Plymouth Nuclear Matters Committee  
Town of Plymouth  
11 Lincoln Street  
Plymouth, MA 02260

RE: Pilgrim Nuclear Power Station  
Direct Torus Vent System

SUMMARY AND COMMENTS ON THE APRIL 12, 1989 ACCIDENT  
AT THE PILGRIM NUCLEAR POWER STATION  
PLYMOUTH, MASSACHUSETTS

# RCIC SYSTEM

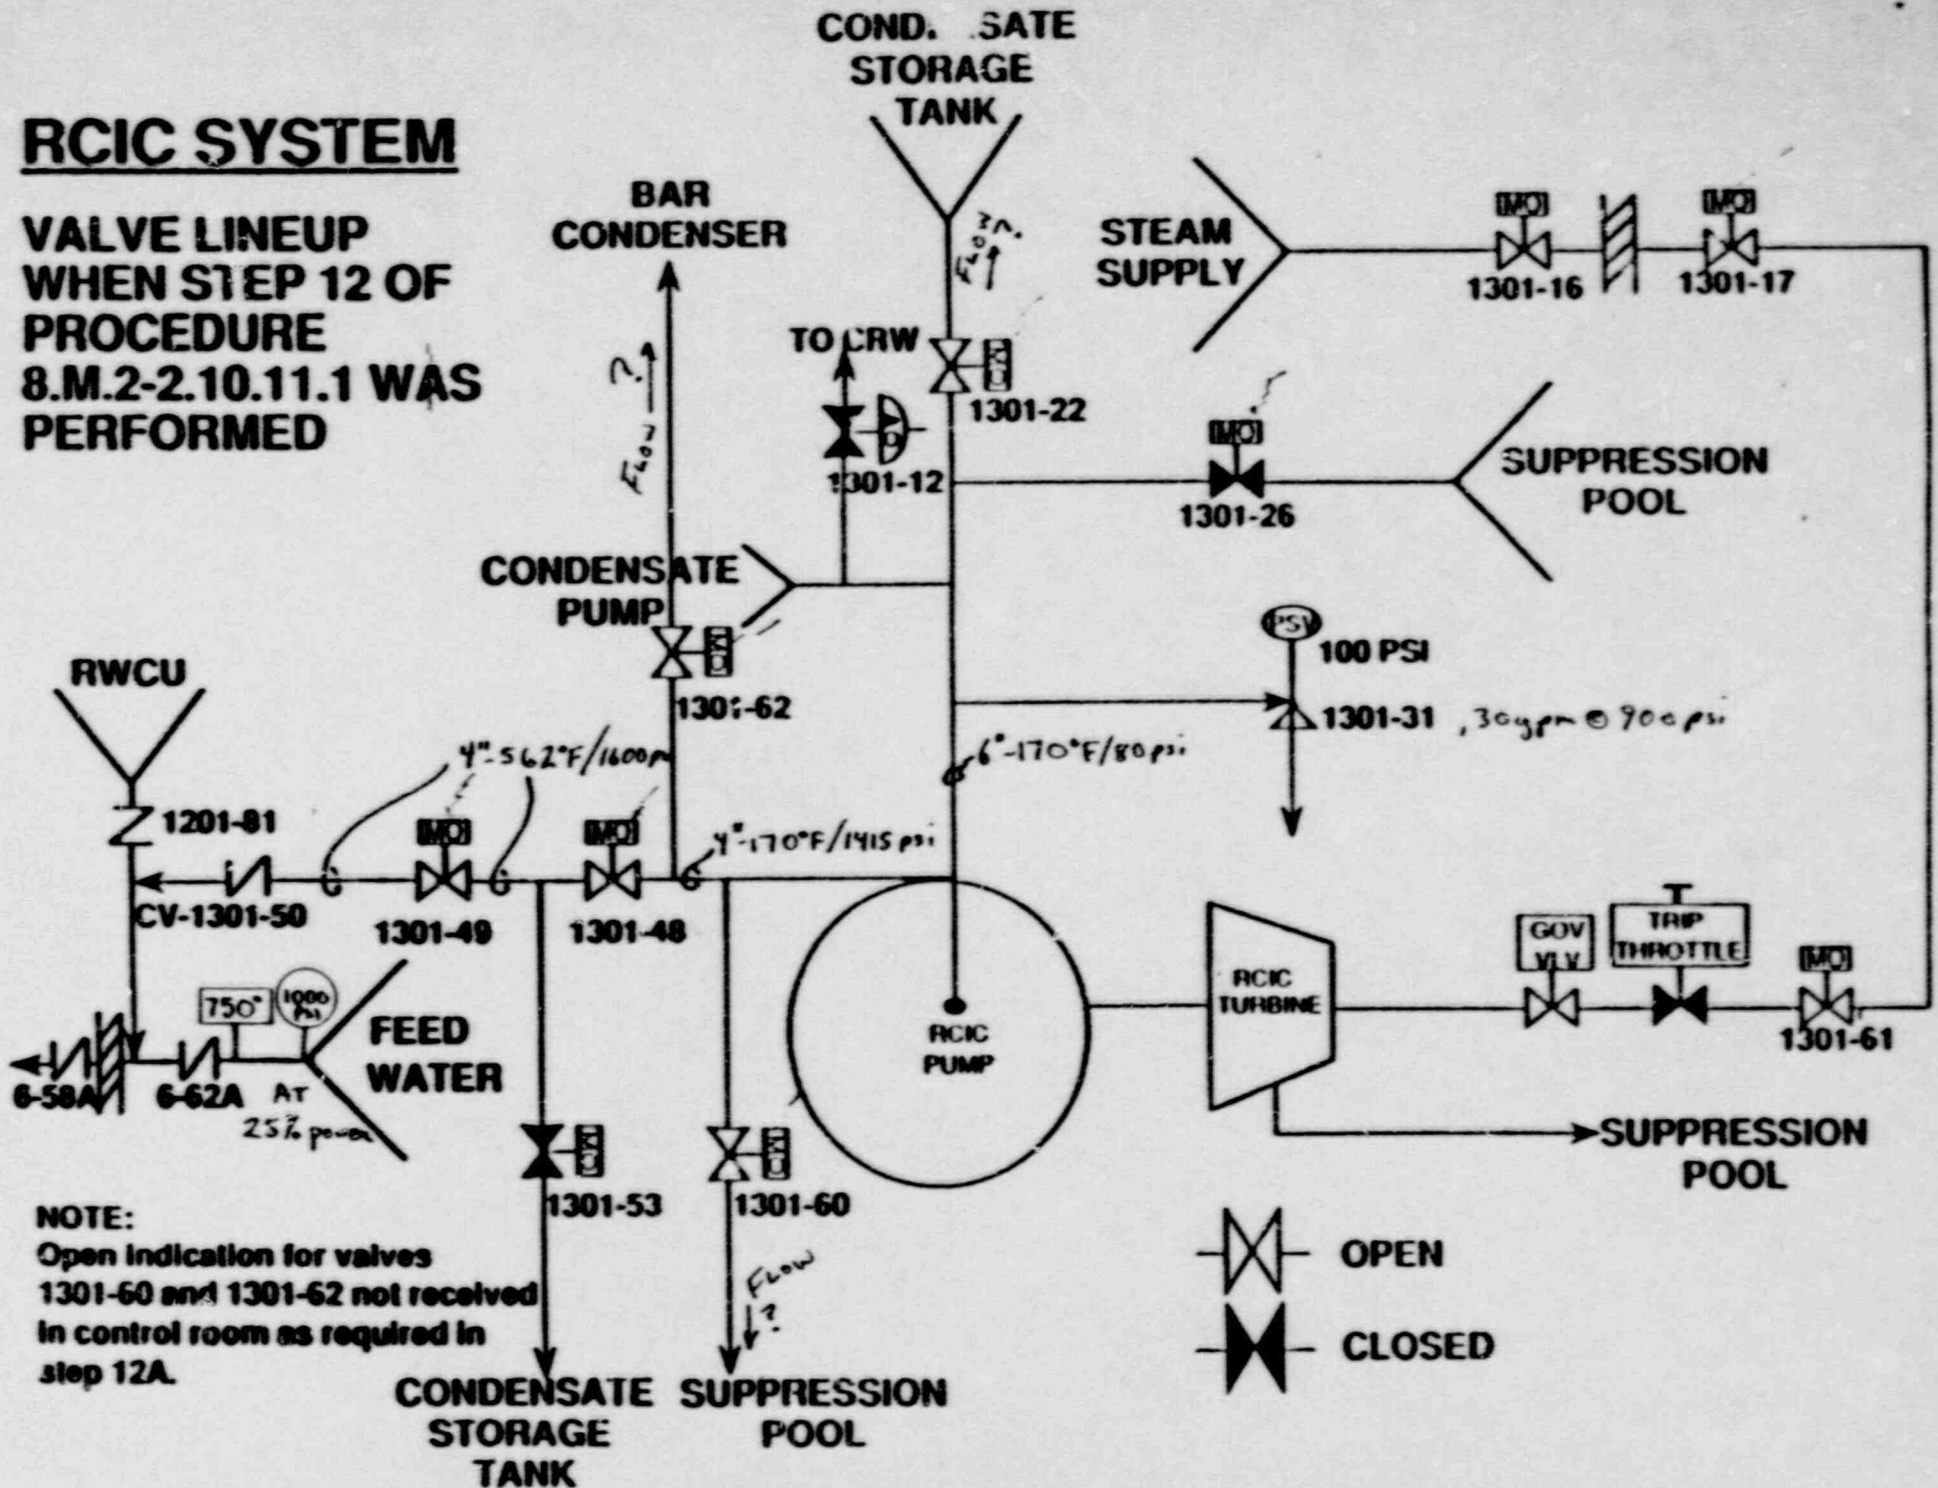
VALVE LINEUP  
WHEN STEP 12 OF  
PROCEDURE  
8.M.2-2.10.11.1 WAS  
PERFORMED

Open indication for valves  
1301-60 and 1301-62 not received  
in control room as required in  
step 12A.
